**NOTICE OF ADDENDUM
ADDENDUM NO. 2**

**CONTRACT NO. 7939
MADISON MUNICIPAL BUILDING - RENOVATION**

This addendum is issued to modify, explain or correct the original Drawings, Specifications, or Contract Documents and is hereby made a part of the contract documents.

EXHIBIT H
S101

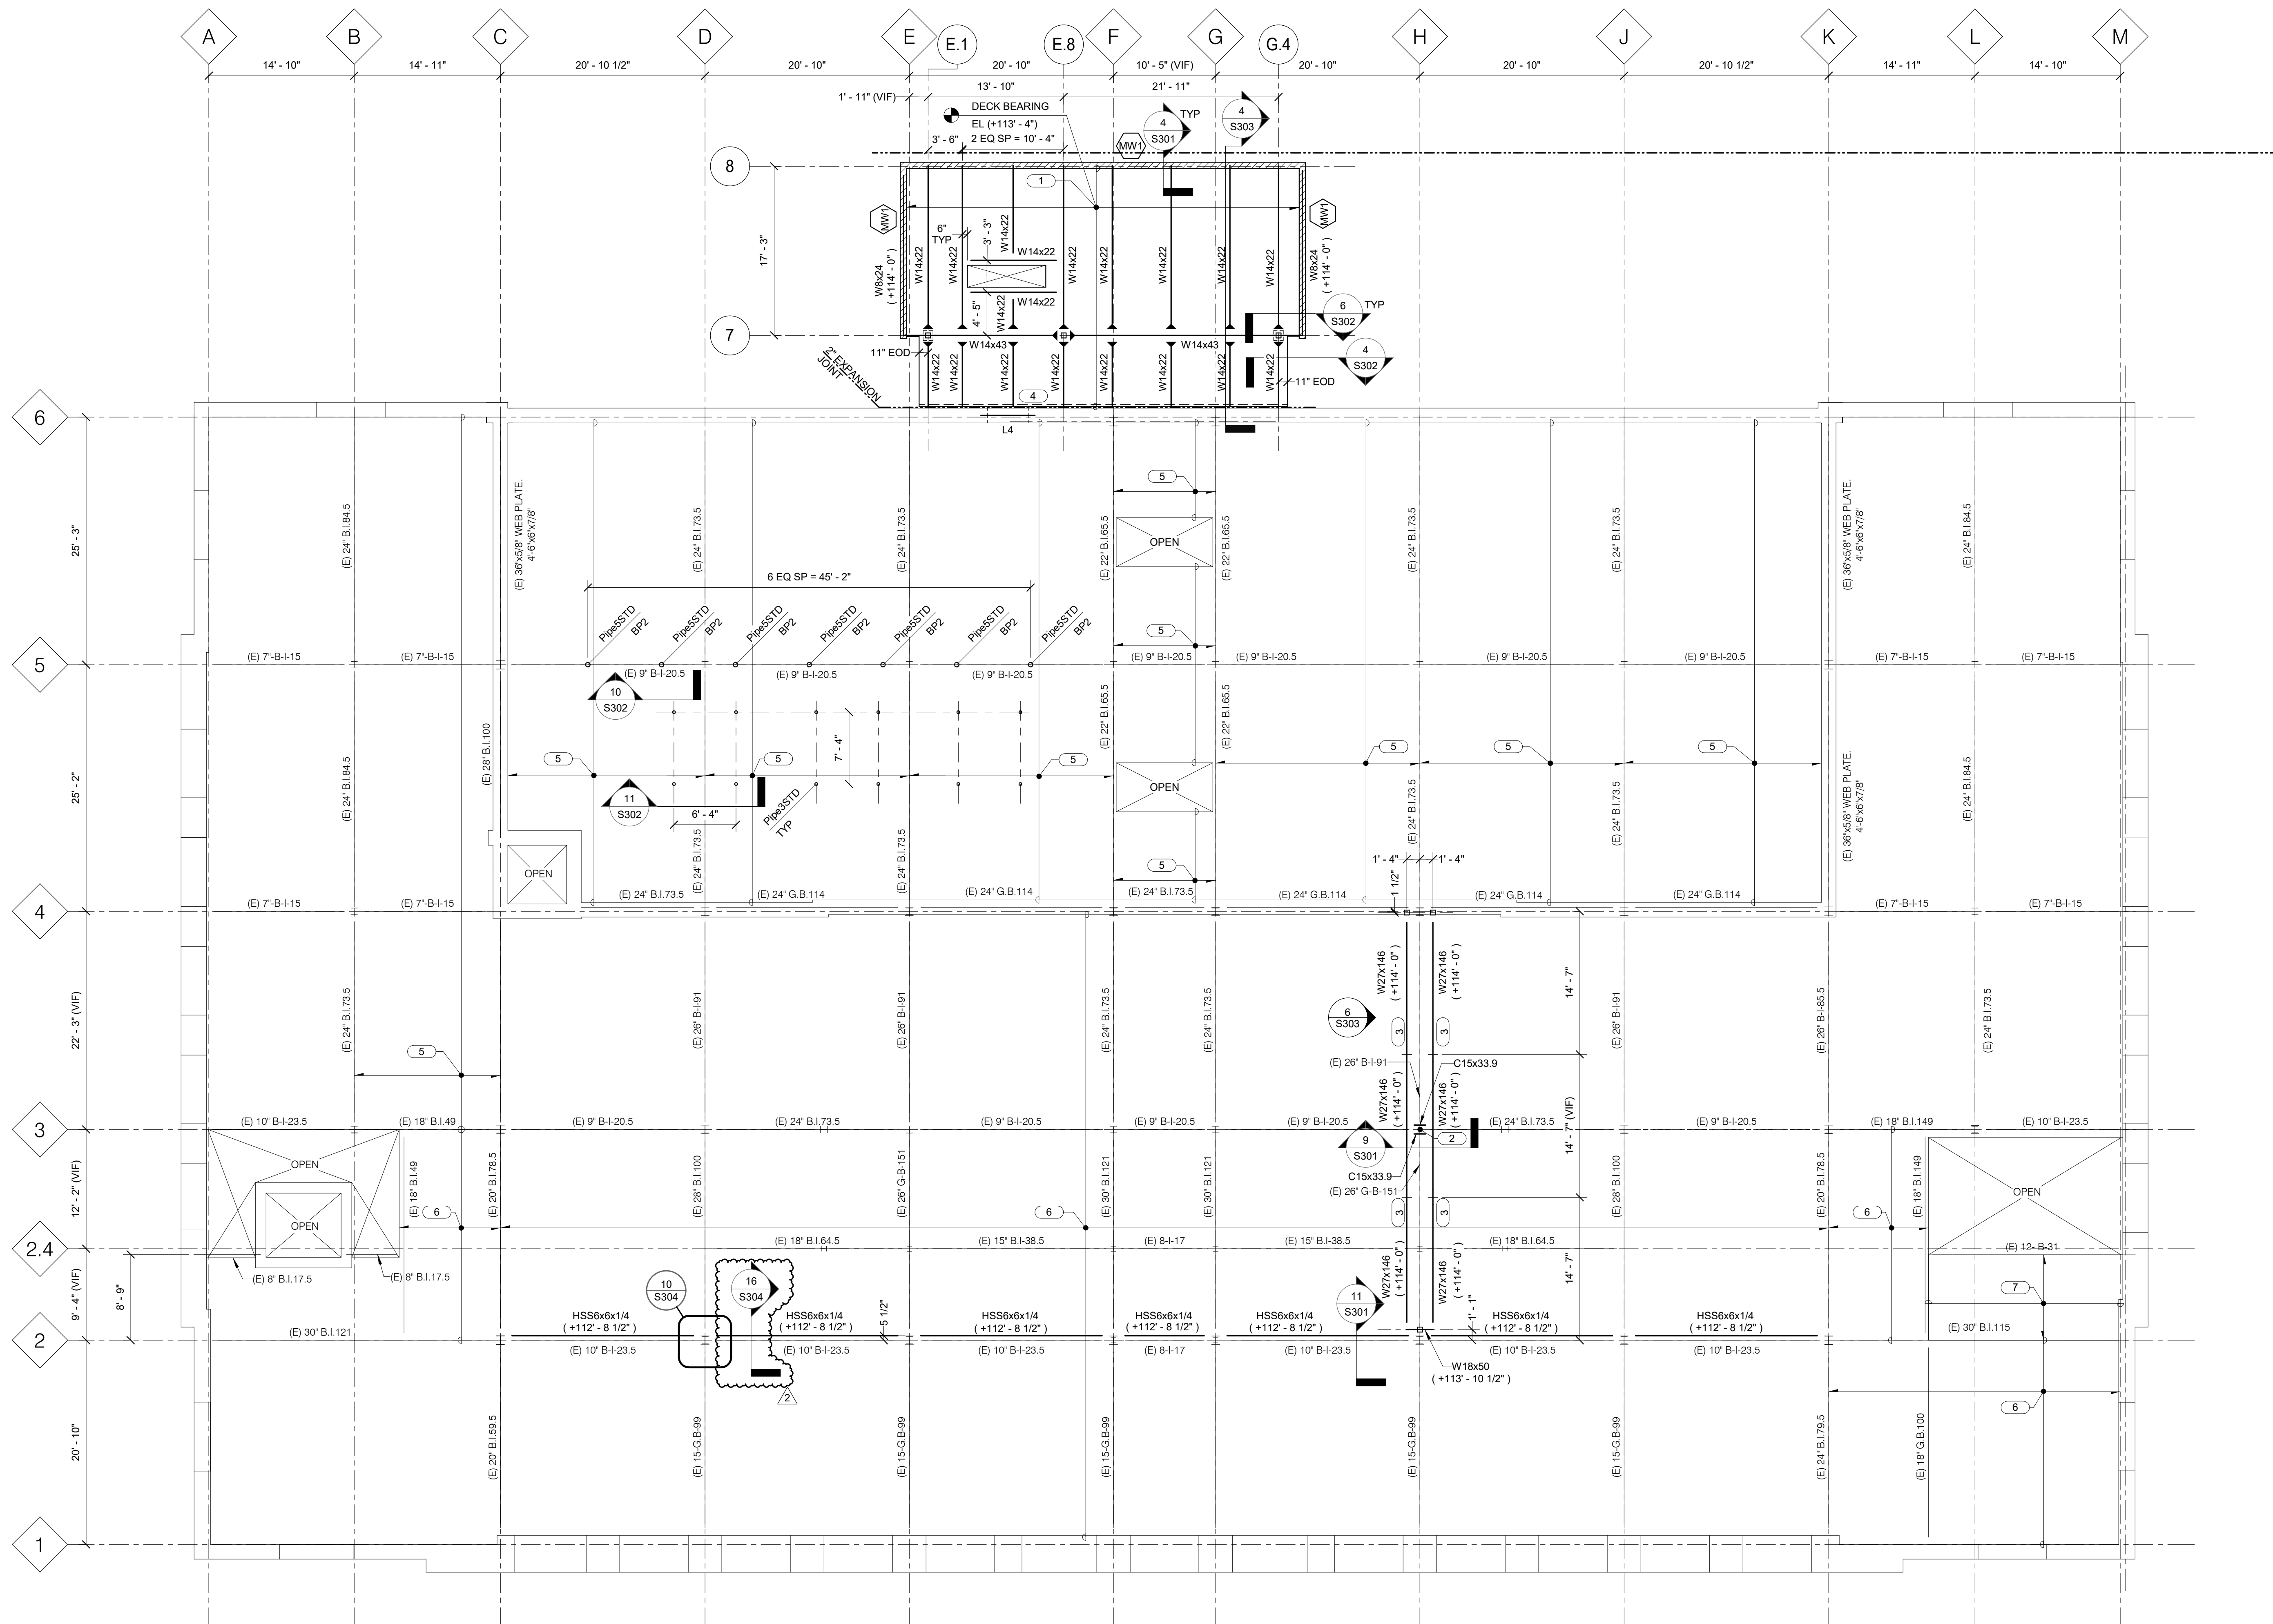
1. Drawing S101 – FIRST FLOOR FRAMING PLAN
 - a. **REVISE** column base plate tags at entry vestibule, conference rooms and north addition per revised sheet S101.

**EXHIBIT H
 S102**

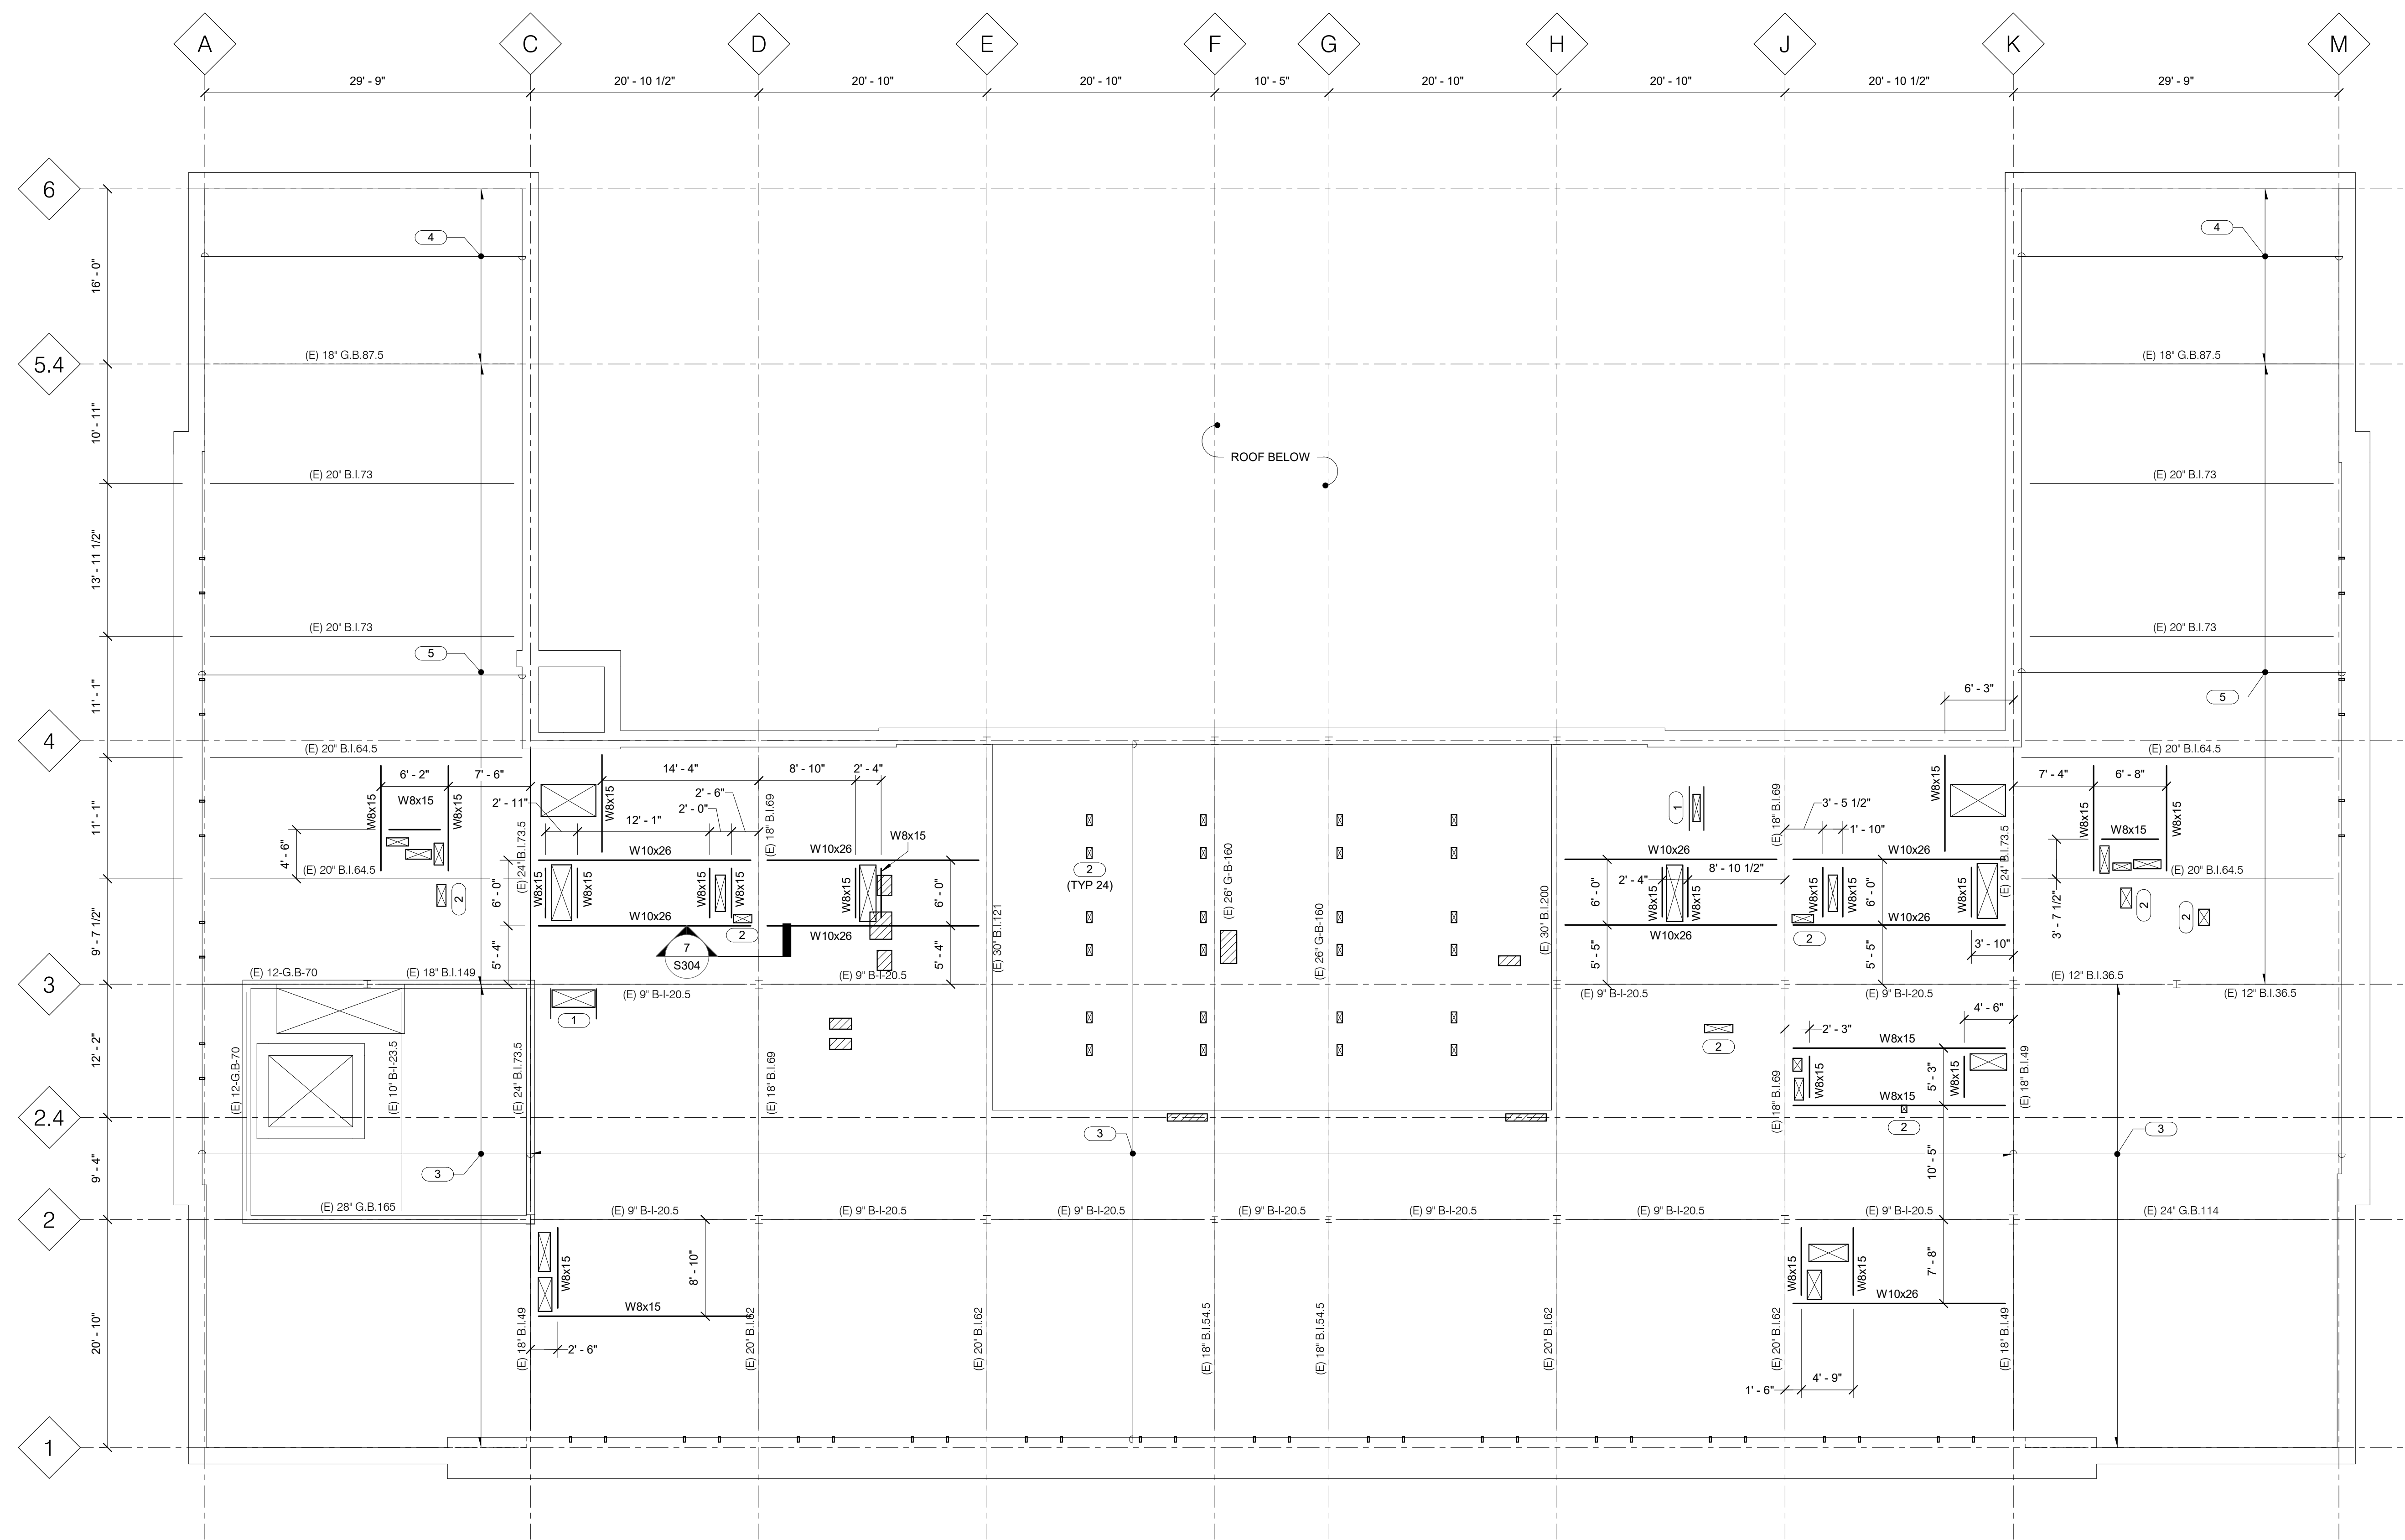
2. Drawing S102 – SECOND FLOOR FRAMING PLAN
 - a. **ADD** section cut per revised sheet S102.
3. Drawing S103 – THIRD FLOOR FRAMING PLAN
 - a. **ADD** section cut per revised sheet S103.
